Re: San Francisco Lighting Project

I have reviewed the design for the proposed "Light Rail" public art installation from Parsons Brinckuoff. Also included was their projects maintenance plan.

Thank you for providing updated drawings. Per my phone message, please revise the drawings to include the following from our understanding at the Nov. 20th meeting (with MTA Tim Lipps) and submit for our approval:

LIGHTRAIL PROJECT

MARKET ST. - MESSENGER WIRE TERMINATION

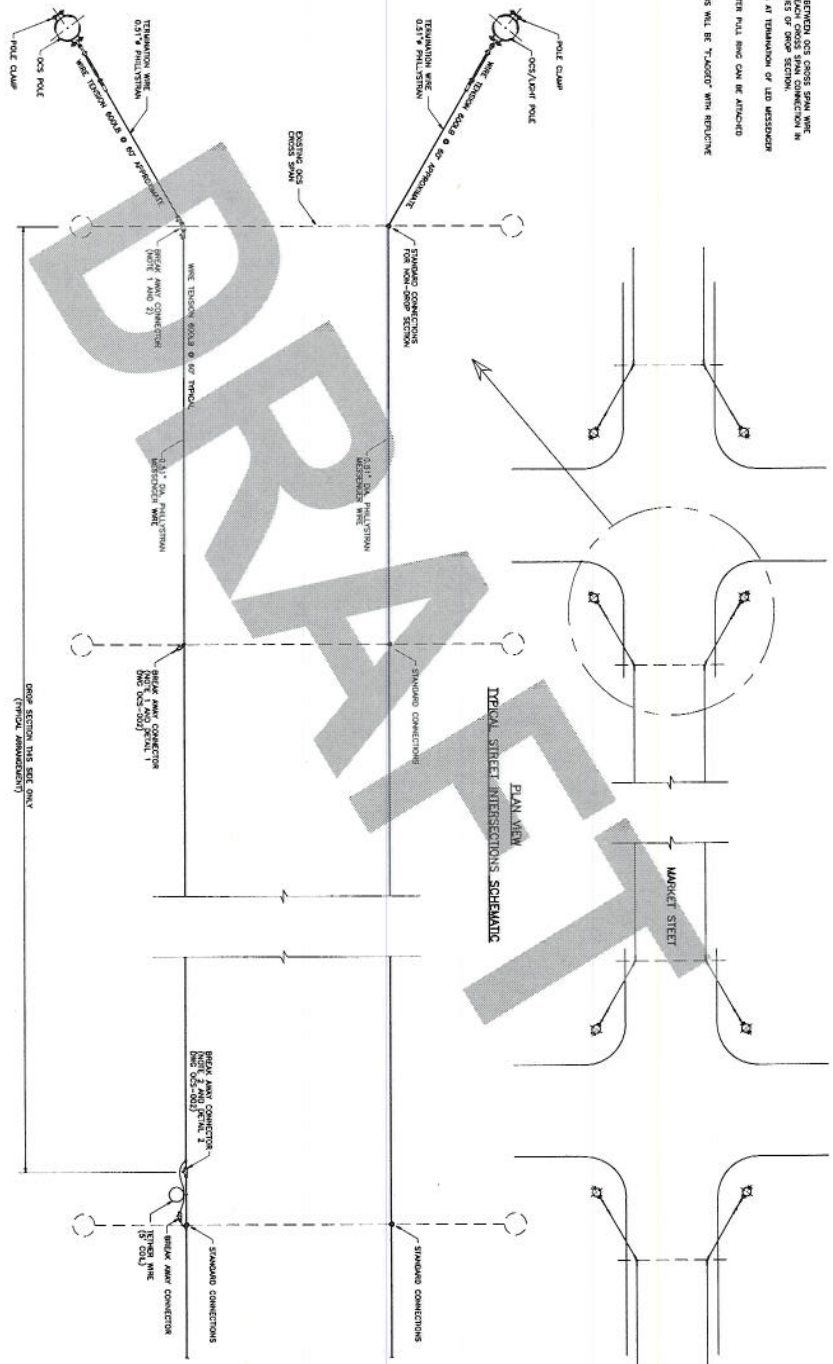
2. Please explain and provide a detail of the dead-end stops on the messenger wire (including points of attachment) and how it will prevent the tensioned lines from springing when released

- NOTES**
1. INSTALL BREAK-AWAY SHOCKLE BETWEEN 100 CROSS POLE WIRE AND LED MESSENGER WIRE AT EACH CROSS SPAN CONNECTION IN DRIP SECTION OR AT EXTREMES OF DRIP SECTION.
 2. INSTALL BREAK-AWAY SHOCKLES AT TERMINATION OF LED MESSENGER WIRE.
 3. IF NECESSARY A LARGER DIAMETER PULL RING CAN BE ATTACHED TO THE SHOCKLE WIRE.
 4. BREAK AWAY SHOCKLE LOCATIONS WILL BE "TAGGED" WITH REFLECTIVE TAPE.

MARKET ST. - CROSS SPAN

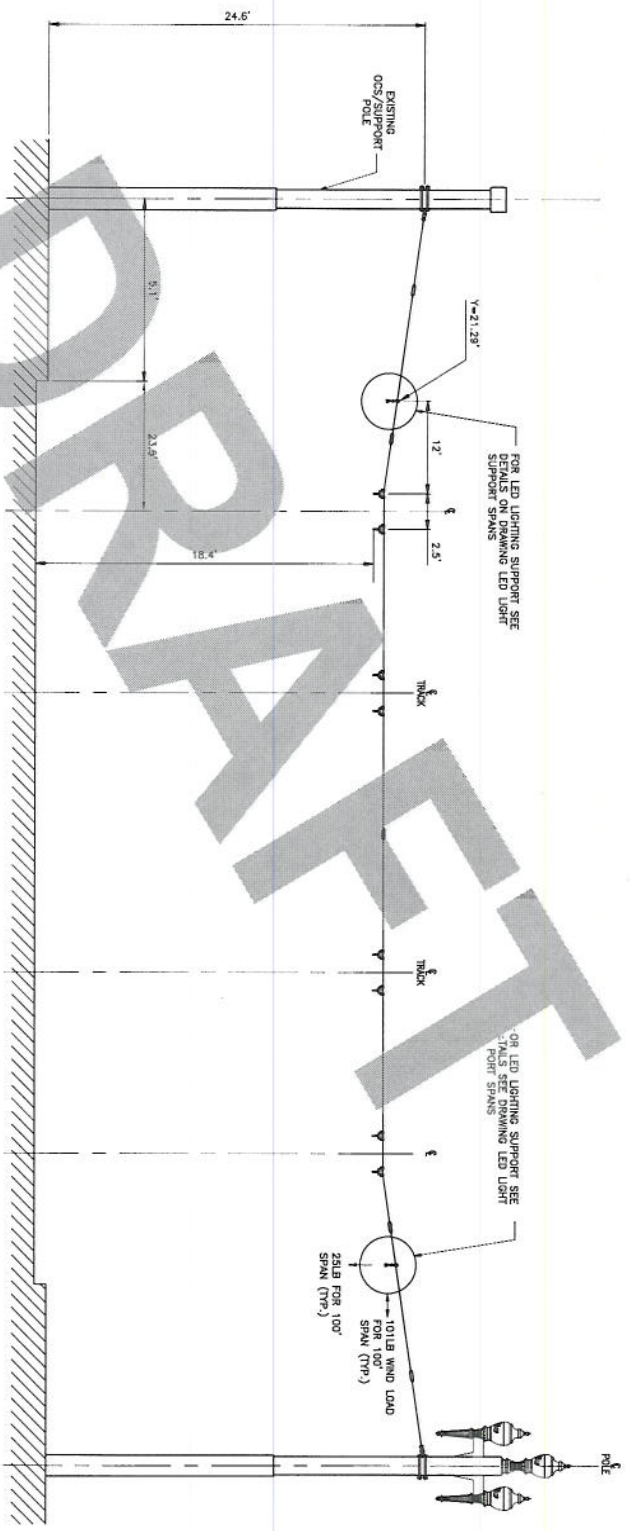
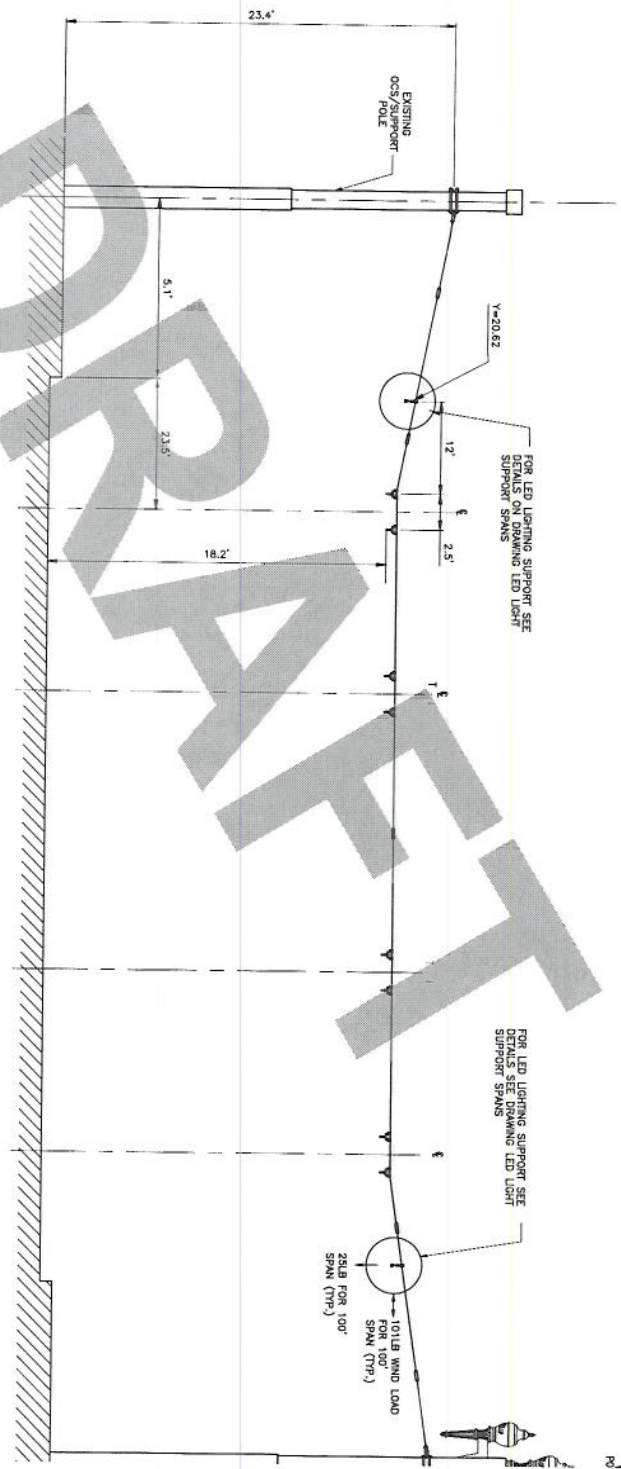
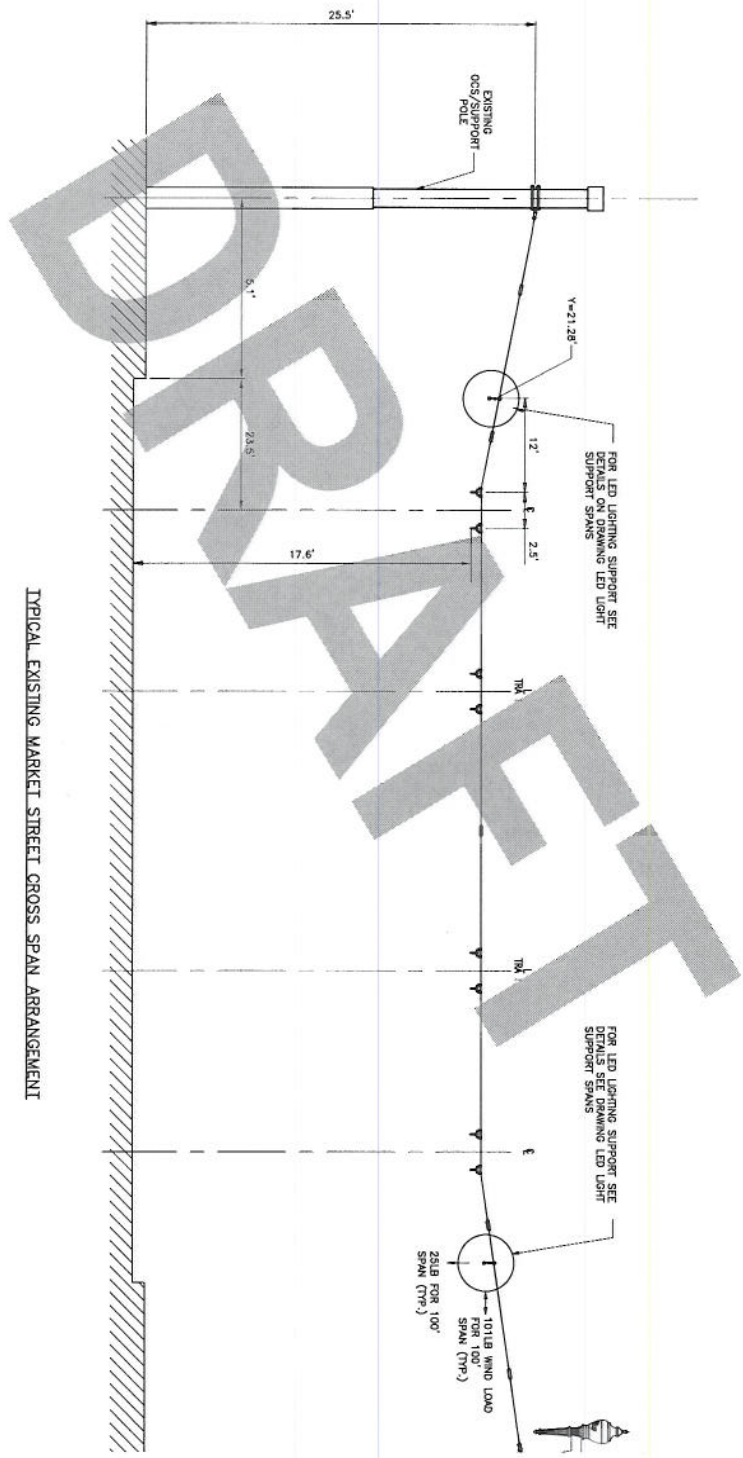
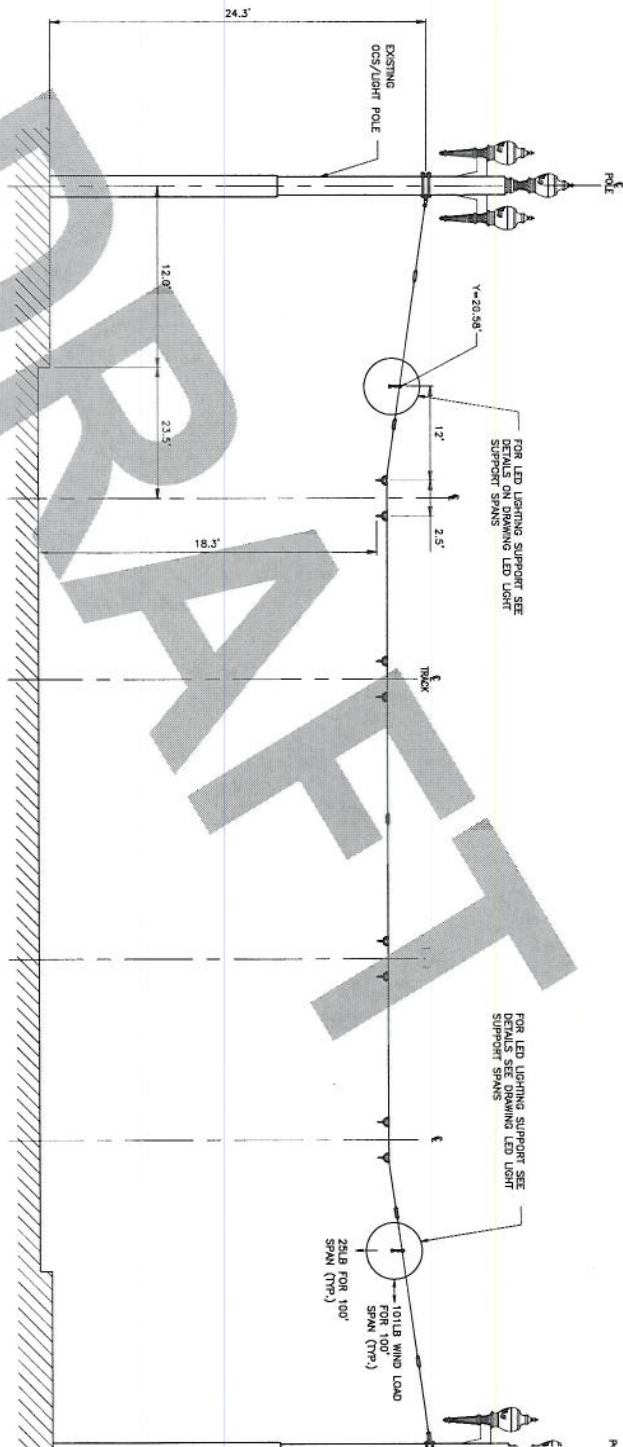
1. The lightrail support and light tubes shall be located on the curb side of the insulator and as close to the insulator as possible (not (4) feet from the insulator as indicated on the drawings). Please indicate and install the lightrail support and light tubes no further than (5) ft. (6) in. from the Muni high-tension wire closest to the curb; this will satisfy Muni overhead wire concerns (the system will be on the curb side of the insulator and at least four feet from the Muni wire) and possibly reduce the number of hook pull release locations required to provide SFFD aerial access.

4. Please include the following two additional notes on the drawings, and please correct the note numbering:
 - * When the minimum dimension from the curb to light rail support and light tubes is determined to be less than (12) feet, the SFFD shall be consulted and the aerial access condition addressed to the satisfaction of the SFFD during installation.
